## Johnson Gill Annex and Courthouse 1 Kings Highway, Middletown, NJ

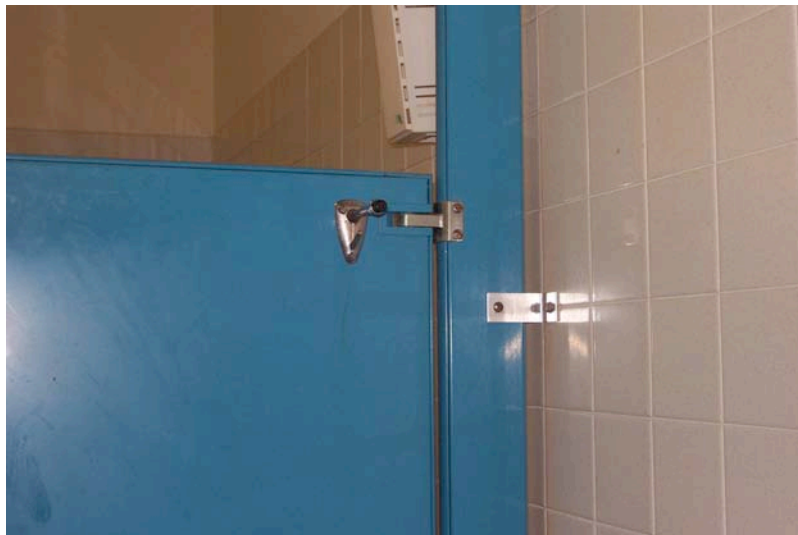
- i. There is a pinch lock on the stall door which requires pinching, grasping, and twisting of the hand and wrist, contrary to ANSI section 404.2.7 and ADAAG section 4.13.9.
- k. The stall does not have a self closing door, contrary to ANSI section 604.8.

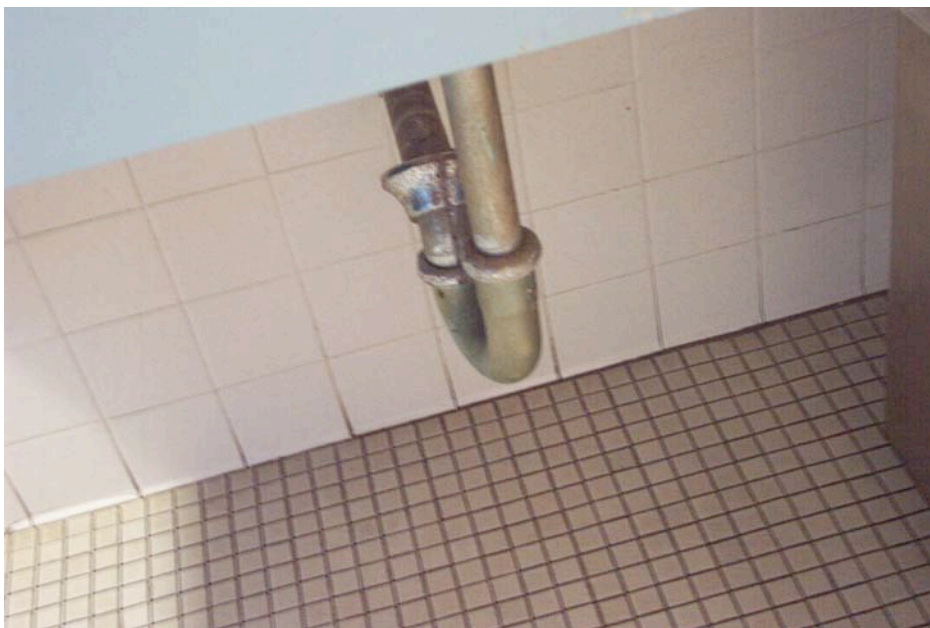
- g. There are round handles on the faucets which require guests to twist with the wrist, contrary to ANSI section 309.4 and ADAAG section 4.19.5.

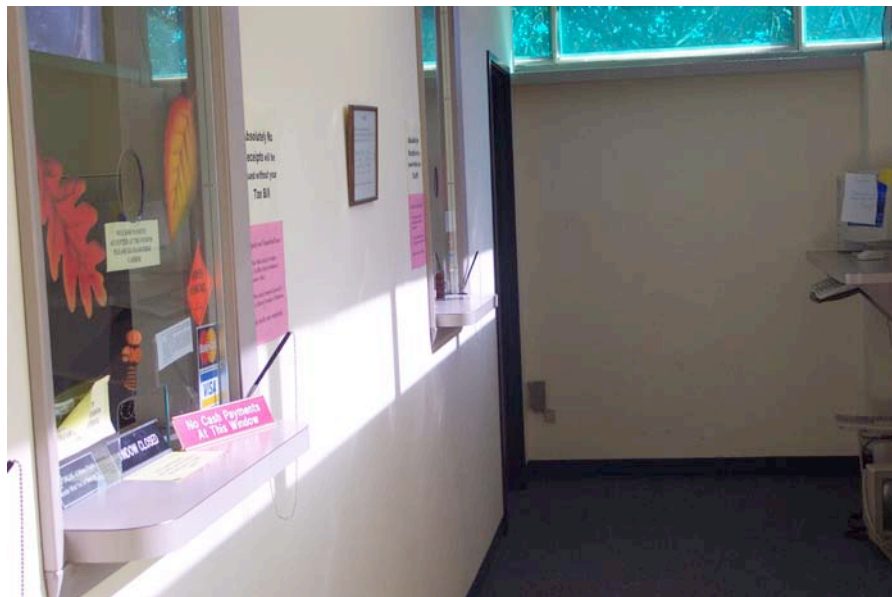
- i. There is a pinch lock on the stall door which requires pinching, grasping, and twisting of the hand and wrist, contrary to ANSI section 404.2.7 and ADAAG section 4.13.9.

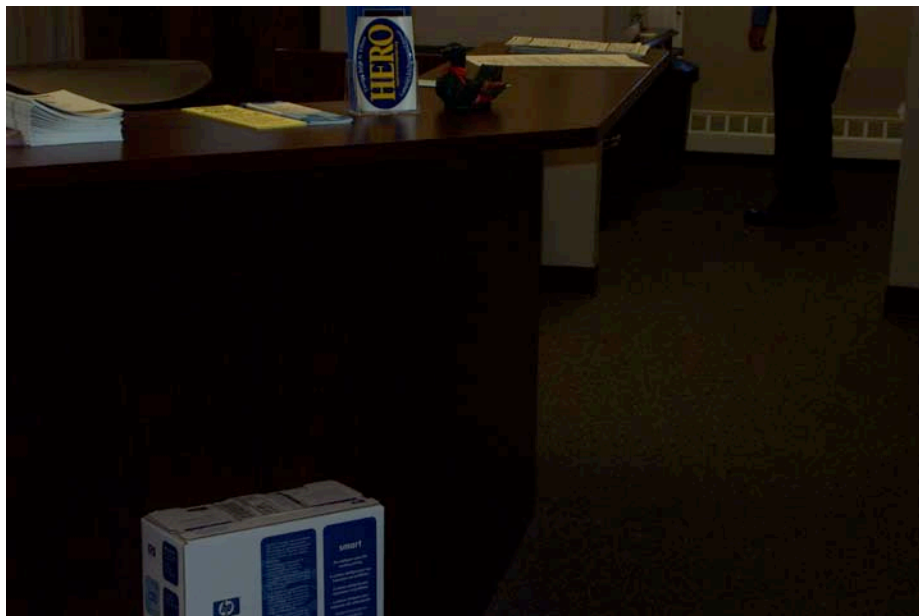
10. The coke machine coin slots measure 55 inches above the finished floor, contrary to ANSI sections 308.2.1 and 308.3.1 and ADAAG section 4.2.6.

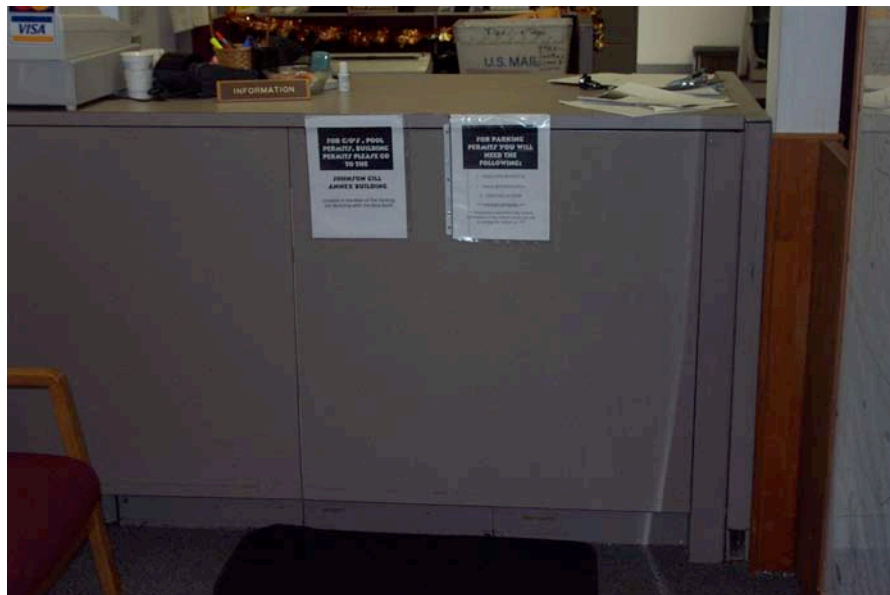
15. The ramp leading to the Mayor's Office has a slope of 11.9% and does not contain the required handrail extensions, contrary to ANSI sections 405.2 and 505.10.1 and ADAAG sections 4.8.2 and 4.8.5(2).

Note: The hand rails that are installed presently are not secured properly and could buckle when used.
